Summary of Items Discussed in APSEC Discussion Forum (ADF) 1/2025 on 14 February 2025

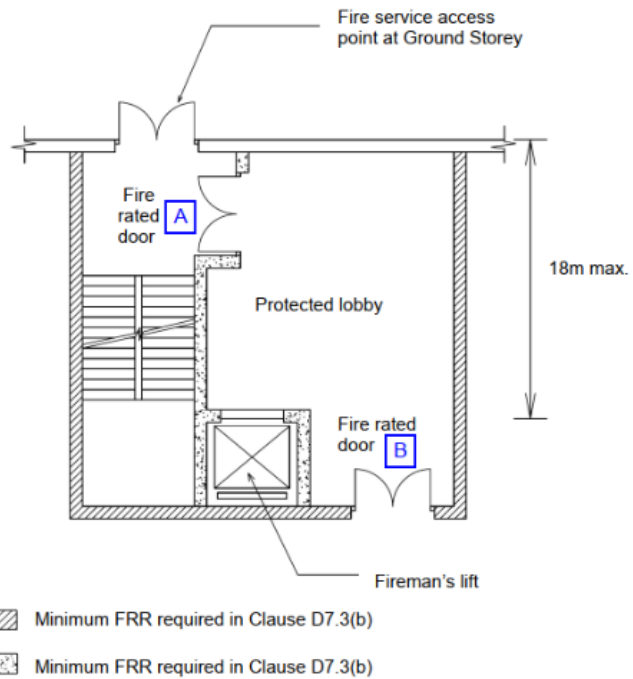
| | Items proposed by Convenors for Discussion | Summary of Discussion and BD's Response |
|----|---|---|
| 1. | <p><u>Door Closer for Door Panel adjacent to the Required Exit Door for Residential Unit</u></p> <p>It is very often that, beside the required exit door, an “additional adjacent door panel” usually of a smaller size is provided at the main exit door leading from a residential unit to a common corridor on a residential floor. The purpose for such “additional adjacent door panel” is not for fulfilling the required exit door width but for convenience like the moving of furniture in or out of the concerned residential unit.</p> <p>Provided that the required exit door is already fulfilling the exit door width requirements and that “additional adjacent door panel” is normally at a locked position and of the same fire-rating and construction as the required door exit door, it is our understanding that a door closer will NOT be required for said “additional adjacent door panel”.</p> <p>Would BD please advise if our understanding is correct or not?</p> | <p>BD advised that according to item 15 of ADF 3/2015 on 29 May 2015, double-leaf door at residential flat with the smaller leaf less 600 mm wide was acceptable as long as it would not be subject to daily use but only be opened in rare occasions such as the moving of large furniture. By the same token, BD considered the non-provision of door closer at the “additional adjacent door panel” required under Clause C16.1 of the Code of Practice for Fire Safety in Buildings 2011 (2024 Edition) (FS Code) acceptable, provided that such door panel was provided with the requisite fire resistance rating (FRR), less than 600 mm wide, normally maintained at a locked position, not contributing to minimum width of exit and not serving as an exit door.</p> |

SCENARIO 1

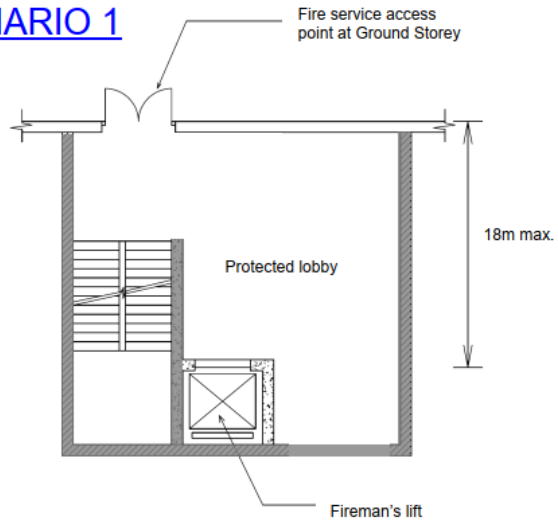
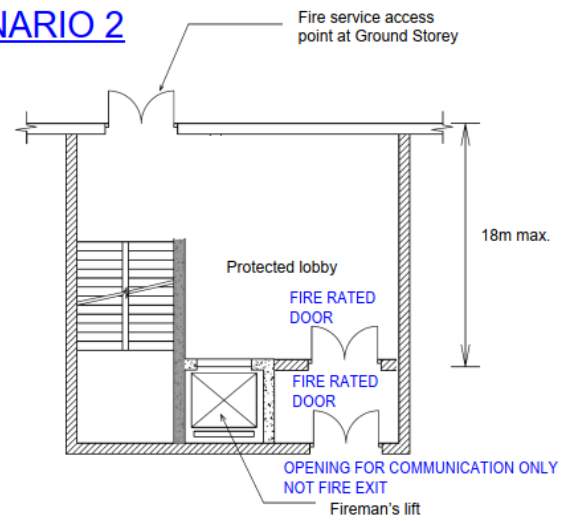
| <p>2.</p> | <p><u>Diagram D4 of the FS Code – Access to a Fireman’s Lift at Ground Storey</u></p> <p>Diagram D4 of the FS Code extracted below illustrates the access to a fireman’s lift at ground storey, with fire rated doors between the protected lobby and an required staircase discharging to the fire service access point (FSAP) (Door “A”); and between the such protected lobby and the reminder of the ground storey (Door “B”).</p> | <p>BD advised that according to item 20 of ADF 3/2024 on 9 August 2024, BD would favourably consider Scenario 1 and 2 in which a required staircase opened off the passage from the FSAP to the fireman’s lift required under Clause D7.3(b) of the FS Code, subject to the compliance with requirements under Clause B9.1 of the FS Code and no objection from the Fire Services Department (FSD).</p> |

Will BD favourably consider the following scenarios illustrated in the below diagrams:

Scenario 1: If the lobby is completely separated from the remainder of the ground storey, can Door “A” be omitted?

Scenario 2: If Scenario 1 is considered acceptable, can Door “A” be omitted if Door “B” is replaced by a protected lobby?

With reference to item 2 above, BD would favourably consider to accept a required staircase opening off the passage from the fire service access point (FSAP) to the fireman’s lift required under Clause D7.3(b) of the FS Code, provided that the requirements under Clause B9.1 were

| | street. | complied with and there was no objection from FSD. If such required staircase opened off a FRS, Subsection D17 of the FS Code should also be complied with. |

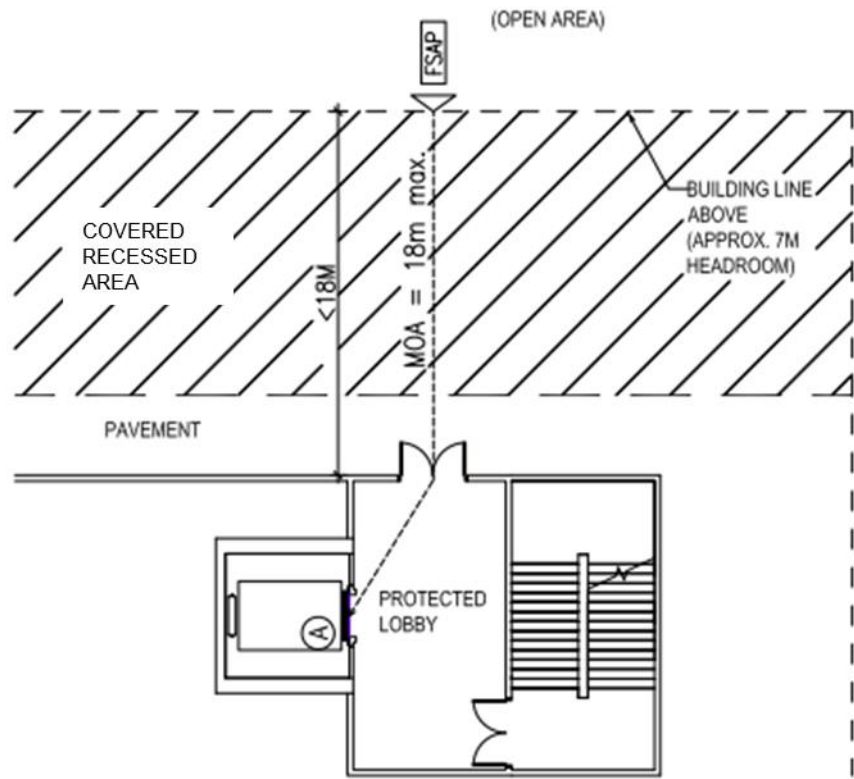
| 8. | <p><u>Covered FSAP</u></p> <p>Regarding Clause B9.1 of the FS Code, BD responded in item 9 of ADF 2/2012 held on 16 March 2012 that <i>“the design of the ground storey discharge point which is recessed from the ultimate edge of the building may be acceptable if the covered recessed area is a common area, open in design, and not encumbered with features carrying fire hazards.”</i></p> <p>We would like to seek BD’s advice on whether this interpretation is still acceptable.</p> <p>If the above interpretation is still acceptable, could BD please advise if the FSAP could adopt the similar principle and be recessed from the building edge.</p> | <p>Regarding Clause B9.1 of the FS Code, BD confirmed that item 9 of ADF 2/2012 held on 16 March 2012 was still pertinent.</p> <p>However, the design of the FSAP should comply with the requirements under subsection D7 of the FS Code. Any application for deviation of relevant requirements would be considered on case basis and subject to the comments from FSD.</p> |

DIAGRAM - TRS LOCATION

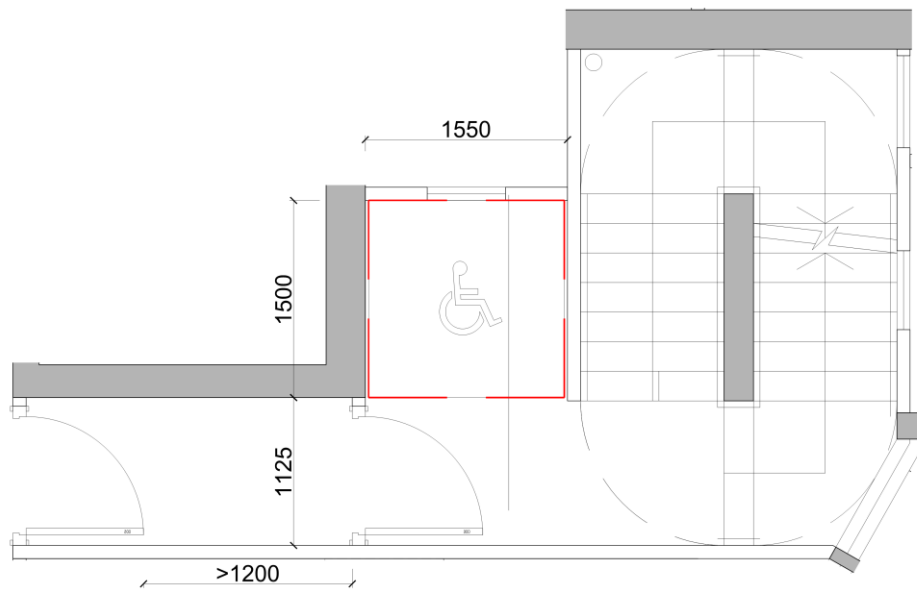
| <p>21.</p> | <p><u>Temporary Refuge Space (TRS) in Landing of Required Staircase</u></p> <p>According to Clause B30.1 of the FS Code, the temporary refuge space can be located in the landing of a required staircase (i.e. within the protected exit, Diagram B6 Example (d) of the FS Code refers):</p>  <p>To our understanding, the user of the TRS (i.e. persons with a disability) should stay safe in the TRS, waiting for assistance and is not expected to return to the common corridor which is an unprotected area. Therefore, the minimum 330 mm wide unobstructed area adjacent to the door handle on the leading face of the fire-rated door required under paragraph 39(1) of the Design Manual: Barrier Free Access 2008 (2024 Edition) (DMBFA) is not applicable and the following layout is acceptable:</p> | <p>BD advised that according to paragraph 37 of the DMBFA, doors should be designed to enable all people especially wheelchair user to enter and leave any room unaided or without undue difficulties. In the regard, BD advised that both doors of the protected lobby doors should comply with the requirements under paragraph 39(1) of the DMBFA to enable the wheelchair users returning from the TRS to the common corridor, and the length of the protected lobby should be not less than 1200 mm, excluding space for door swings, to allow space for manoeuvring wheelchairs according to paragraph 31(c) of the DMBFA.</p> |

Figure 4.2 Flow Chart Showing Procedures for Dealing with Temporary Works

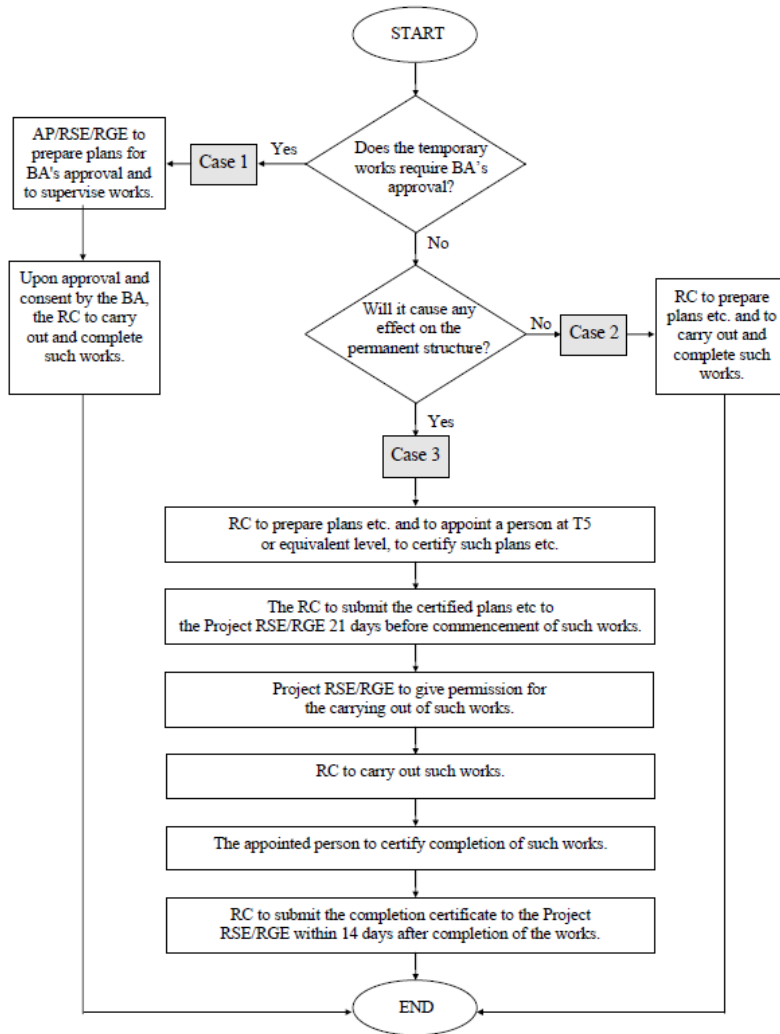
| | <p>Since the installation of such kingposts falls into Case 2, the procedures related to Case 3 requiring RC to submit the certified plans to the Project RSE/RGE 21 days before commencement of works and to submit the completion certificate within 14 days after completion of the works as stipulated in Figure 4.2 of the Supervision Code extracted below do not apply.</p> | |

Please confirm if our understanding is correct.

BD advised that the installation of temporary kingposts which provided supports to the temporary working platforms and/or tower cranes, did not form part of the ELS works shown on the approved plans) and had no effect on the permanent structures, the adjoining buildings and lands by way of overstressing or overloading, was regarded as Case 2 temporary works. The Registered Contractor should follow the working procedures of Case 2 as stipulated under paragraphs 4.9(b) and 4.12 (as appropriate) of the Supervision Code. RSE might include such

| <p>into Case 2 according to paragraph 4.7 of the Supervision Code extracted below, since the works do not cause any effect on the permanent structure. It is thus the Registered Contractor (RC)'s sole responsibility to prepare the prescribed plans, carry out and complete the works with proper site supervision.</p> | <p>temporary kingposts in the ELS and/or foundation plans for information.</p> |

ELEVATION - EAST
1:200 @A1

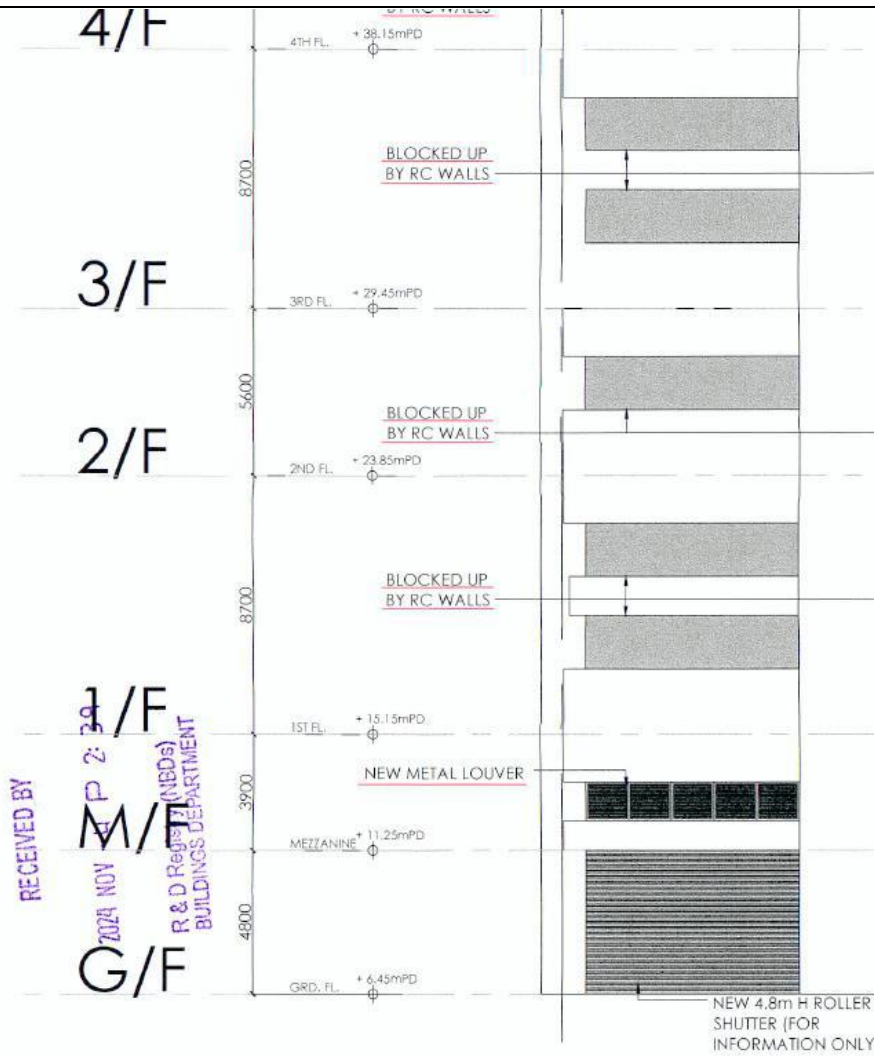
| | Items raised by PBSCA | |
|-----|---|--|
| 23. | <p><u>Revitalisation of Existing Industrial Buildings – GFA Calculation of Void</u></p> <p>The Government has implemented a package of measures to encourage the revitalisation of existing industrial buildings through wholesale conversion of vacant or under-utilised industrial buildings as per PNAP APP-150.</p> <p>In an existing industrial building, the headroom of the major portion of the car park on G/F is 8.7 m.</p> <p>The remaining portion of G/F has a mezzanine floor in it. The headroom of the mezzanine floor is 3.9 m, while the headroom of the ground floor underneath is 4.8 m. As shown in the below diagrams, if the existing mezzanine floor is removed, the headroom of such remaining portion of G/F will be increased to 8.7 m (= 4.8m + 3.9m), which is the same as the existing headroom of 1/F, 3/F and the major portion of G/F.</p> <p>We understand that in the proposed revitalisation project, the area of the void above such remaining portion of G/F as a result of the removal of the existing mezzanine floor can be exempted from GFA calculations. Is PBSCA’s understanding correct?</p> | <p>BD advised that comments could only be provided based on the special circumstances of individual cases. Guidelines set out in PNAP APP-150 and items 21 and 22 of ADF 3/2022 held on 13 May 2022 were relevant.</p> |

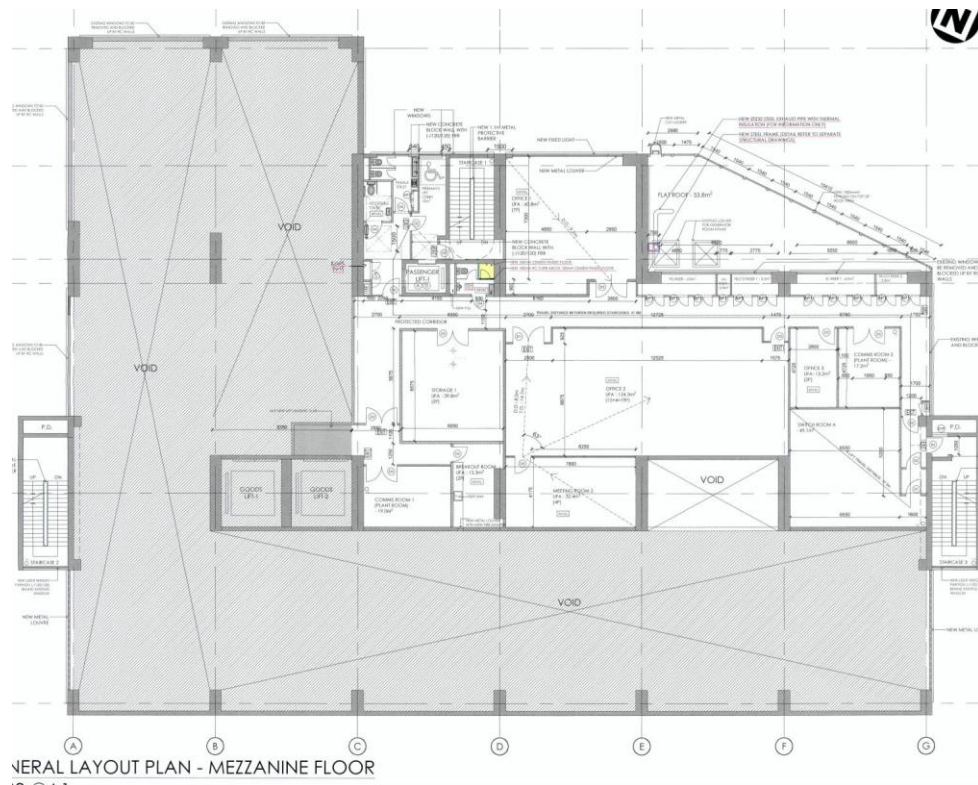
Continuing from the above item, , the existing Staircase No. 2 and Goods Lift No. 1 (circled in blue in the below diagram) do NOT provide access to the mezzanine floor. Can their areas be excluded from the GFA calculation of the mezzanine floor?

BD advised that comments could only be provided based on the special circumstances of individual cases. Guidelines set out in PNAP APP-150 and items 21 and 22 of ADF 3/2022 held on 13 May 2022 were relevant.

GENERAL LAYOUT PLAN - MEZZANINE FLOOR

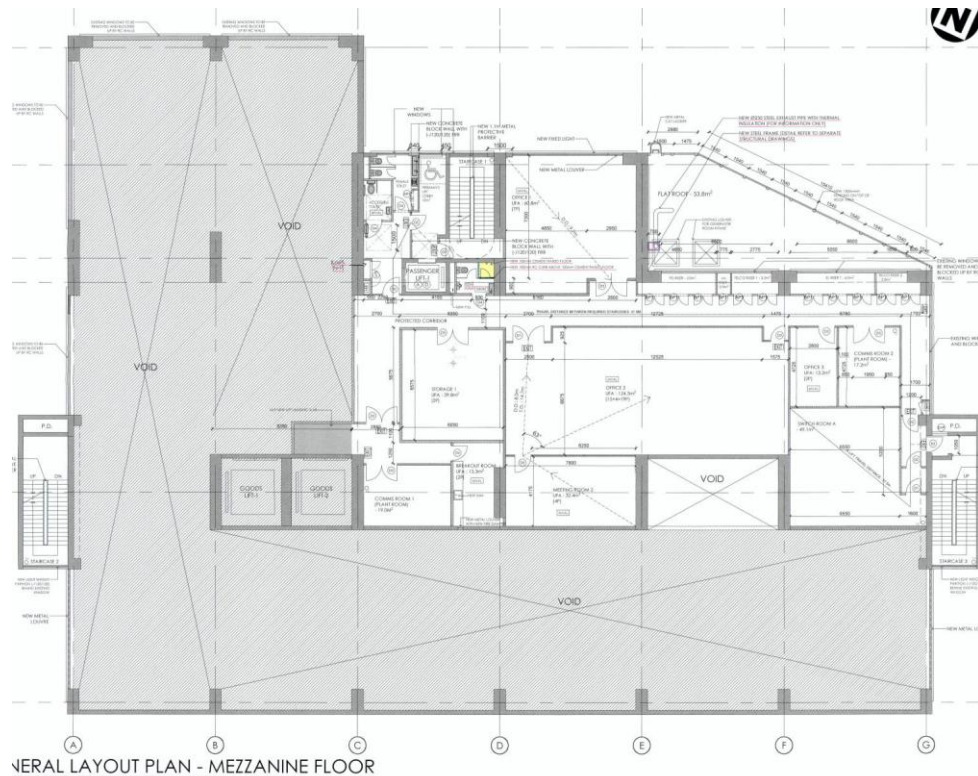
The proposed conversion of an existing industrial building to a data center involves the construction of additional transformer room and switch room on the mezzanine floor as shown in the below diagram.

We understand as per PNAP APP-15, the additional transformer room and switch room should be disregarded from GFA calculation. If the mezzanine floor is solely used for the additional transformer room and switch room with no GFA accountable, we opine that the GFA of the entire mezzanine floor, including circulation areas, lift shafts and staircases, could also be excluded from the GFA calculation. Please advise whether PBSCA’s understanding is correct.

BD advised that comments could only be provided based on the special circumstances of individual cases. Guidelines set out in PNAP APP-150 and items 21 and 22 of ADF 3/2022 held on 13 May 2022 were relevant.

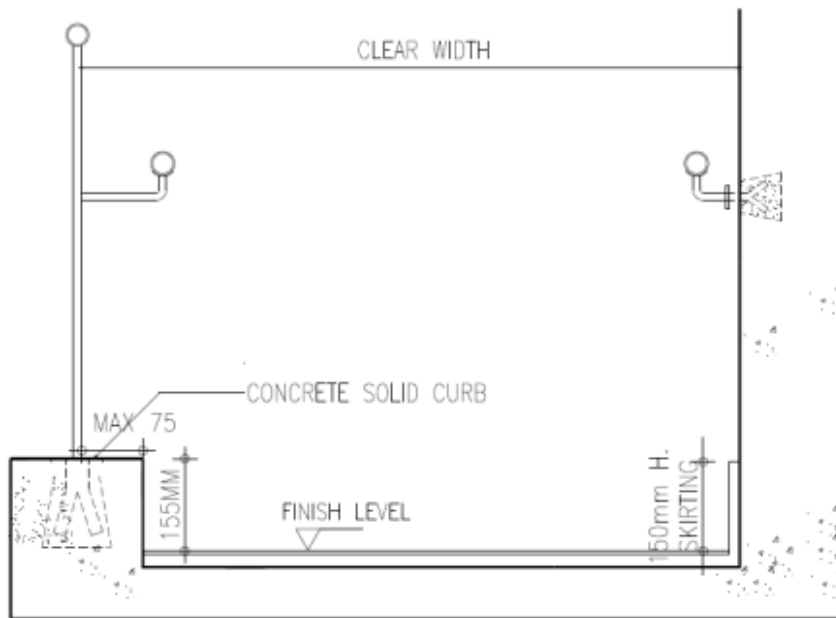
| 29. | <p><u>Curb / Skirting within Required Staircase</u> (Item raised by HKIA)</p> <p>Item 22 of ADF 2/2016 held on 18 March 2016 contained the diagram below:</p> | <p>BD advised that item 22 of ADF 2/2016 held on 18 March 2016 was still pertinent. However, the advice was made in the consideration that the provision of curb was required as part of the protective barrier under the relevant provisions of the B(C)R and B(P)R as well as the guidelines set out in PNAP APP-110. As the skirting was not a required provision under the BO and its allied regulations, the width of required staircases</p> |

BD confirmed in ADF 2/2016 that the width of the required staircase should be measured between the inner side of the balustrade and the wall finish provided that the solid curb with the width at its top on the inner side of the balustrade was not more than 75 mm.

- a) Would BD re-confirm if the solid curb, with the width at its top on the inner side of the balustrade not more than 75 mm, is acceptable to be situated within the required width of staircase?

| | <p>b) Would BD advise if the skirting, with its height not more than 150 mm and thickness not more than 10 mm on each side, is acceptable to be situated within the required width of staircase?</p> | |

should be measured to the surface of the skirting in accordance with Notes (3) of Table B2 of the FS Code. In addition, the width of the curb including the thickness of the skirting and other finishes should not exceed 75 mm.
